**New York Power
Authority**

**Indian Point 3
Improved Technical Specifications (ITS)
Conversion Package**

**Technical Specification 3.4.11:
"Pressurizer Power Operated Relief Valves (PORVs)"**

Maximum Allowable Nominal PORV Setpoint for the
Low Temperature Overpressure Protection System (OPS), 13.3 EFPY

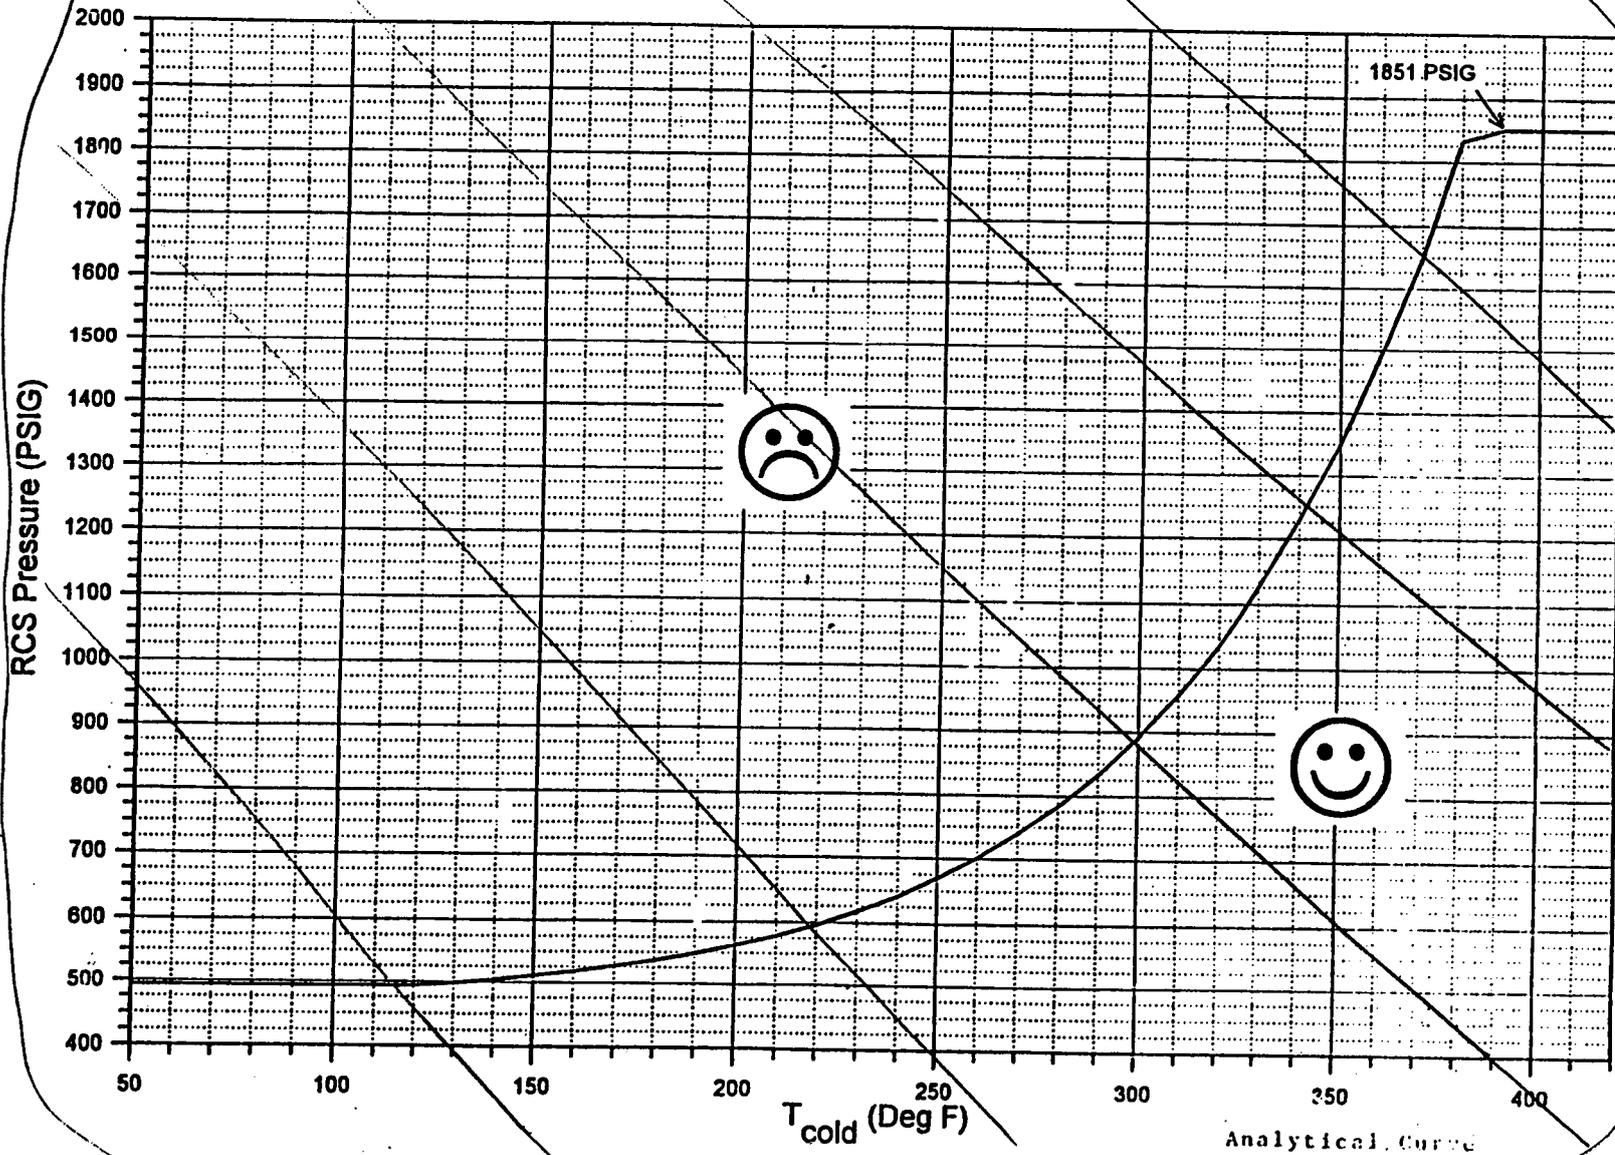
(1) the OPS shall be ~~armed and~~ operable. Both OPS PORVs shall have lift settings not to exceed those given in ~~Figure 3.1.A-2,~~ or PTLR (A.6) (LA.1)

Figure ~~(3.1-3)~~ 3.4.16-1

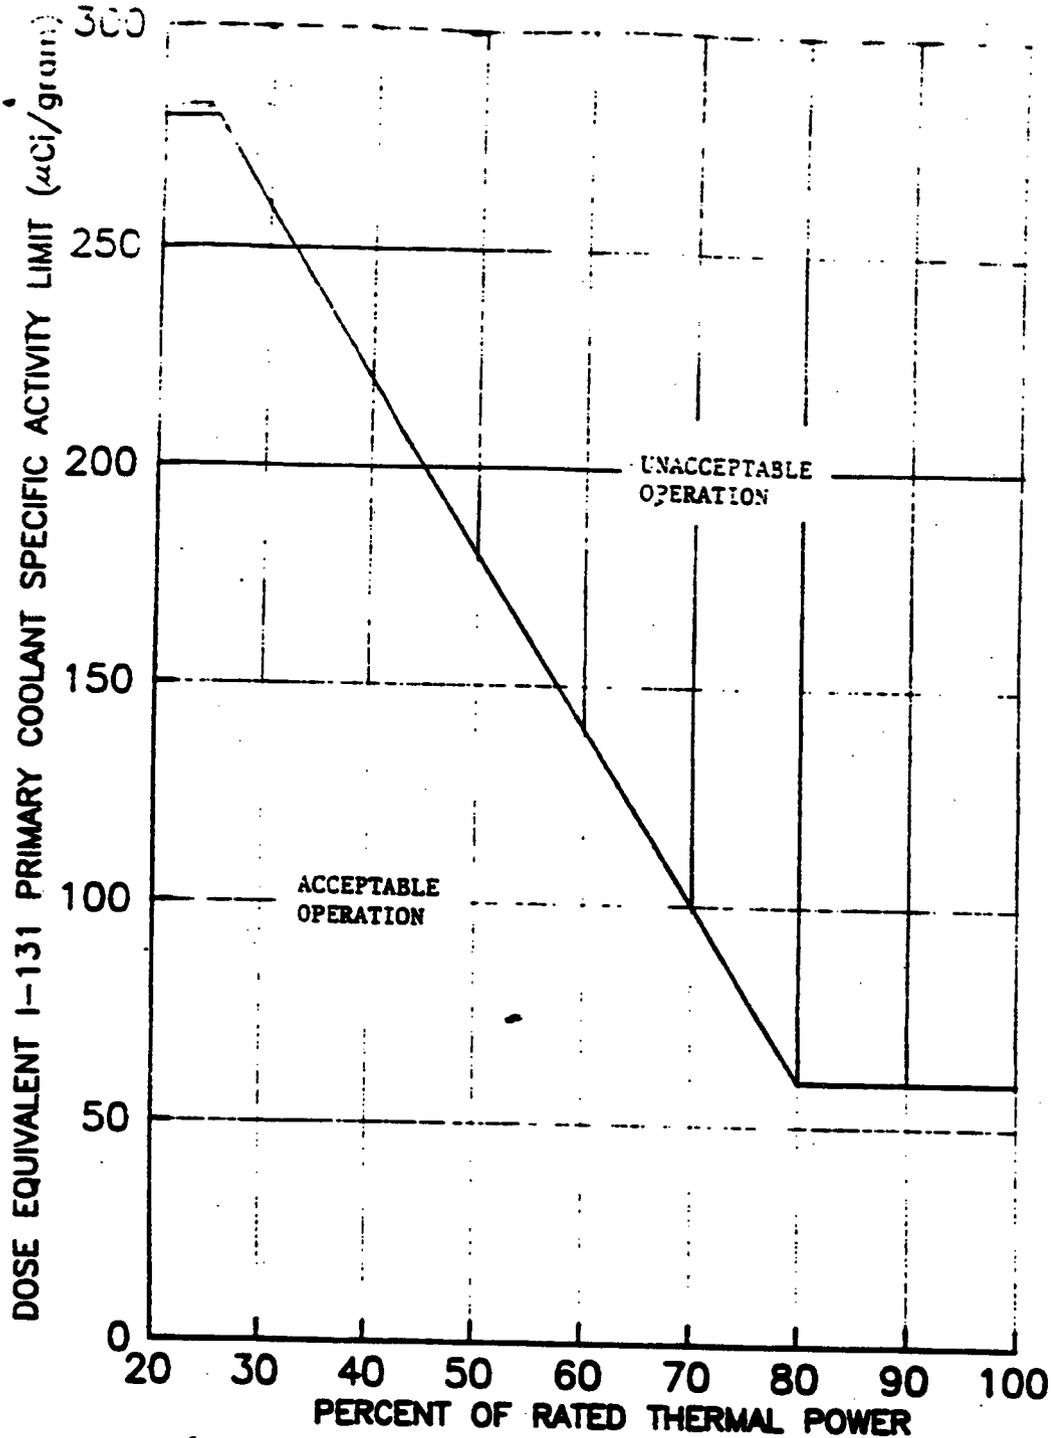
(A.1)

Figure 3.4.16-1 (page 1 of 1)
Reactor Coolant DOSE EQUIVALENT I-131 Specific Activity
Limit Versus Percent of RATED THERMAL POWER

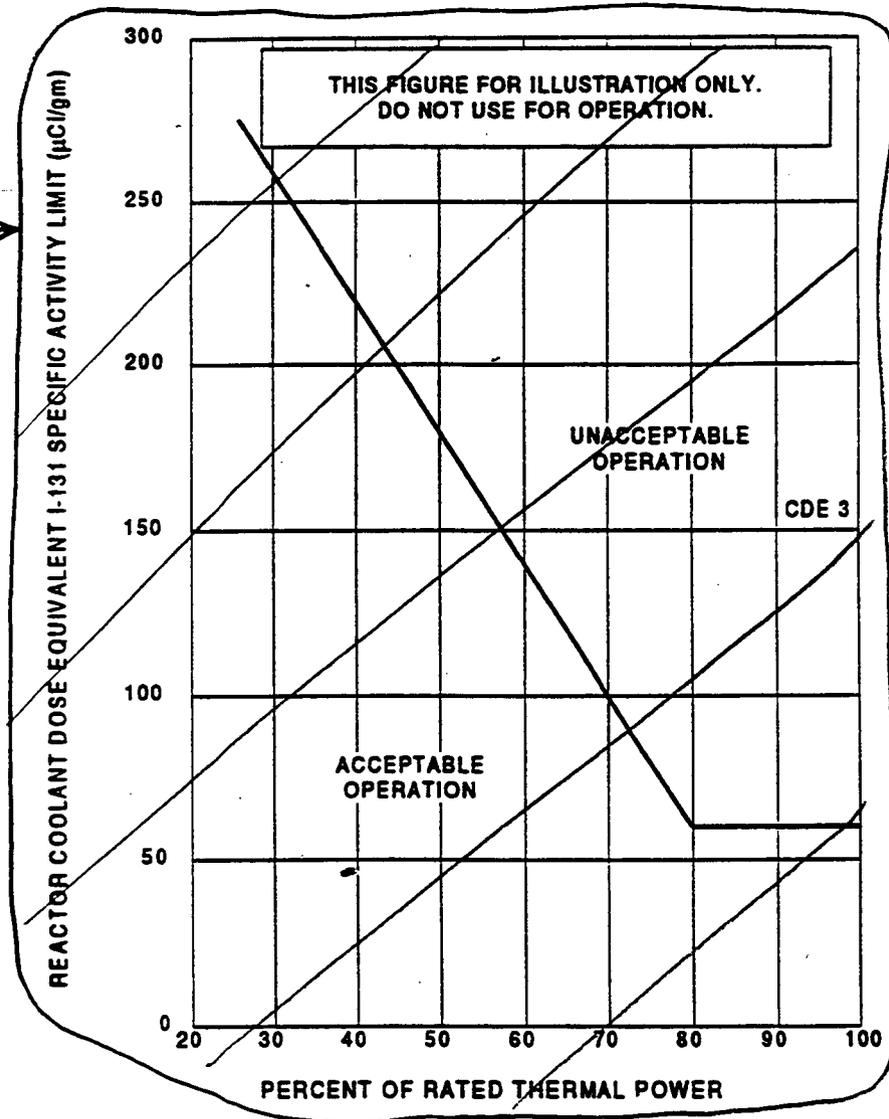
DB.1

Insert:
3.4-46-01
